## Planning, Land Use and Mobility Committee

### **"The District at Warner Center" Mixed Use Residential/Hotel/Commercial**

**Case Report: 6100 Canoga Avenue, Woodland Hills, CA 91367  
Downtown District, Warner Center 2035 Plan  
DIR-2020-5379-SPP-VHCA**

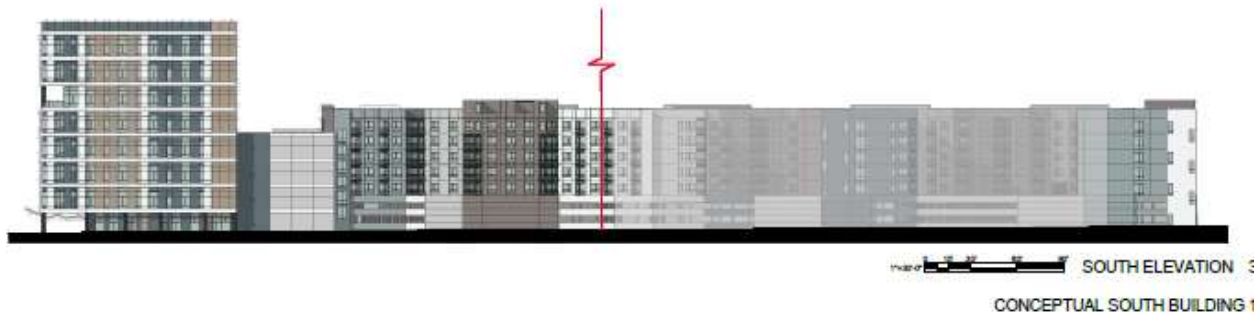
As previously noted, the overall architectural design is highly conservative, somewhat dated and relatively uninspired for both the residential units and the hotel. The overall visual impact of the

project must be carefully considered because it will be one of the most visible in Warner Center.

A careful re-study of the project massing should be considered since the project's master plan appears to have been created to maximize residential housing and little else at the expense of other critical attributes on the almost 8.8-acre site.

The two "tower" elements—along with the 12 story hotel—facing Canoga Ave creates a massive "wall," and elicits a fortress impression. It does not provide any real visual interest for pedestrians, motorists or the Warner Center community, and makes the entire project almost foreboding. Plans show it will be almost entirely surrounded by 6-foot walls.

The architects have attempted to visually reduce some of the massing by stepping down portions of both the north and south residential buildings. The height difference between the 7-story and 5-story parts goes almost unnoticed due to the narrow separation space provided by the central PAOS and the project's overall blocky design. The result is a sense that this is an overwhelmingly massive project for the site--an almost citidel-like project designed to separate it from, rather than connecting it to, the rest of Warner Center.
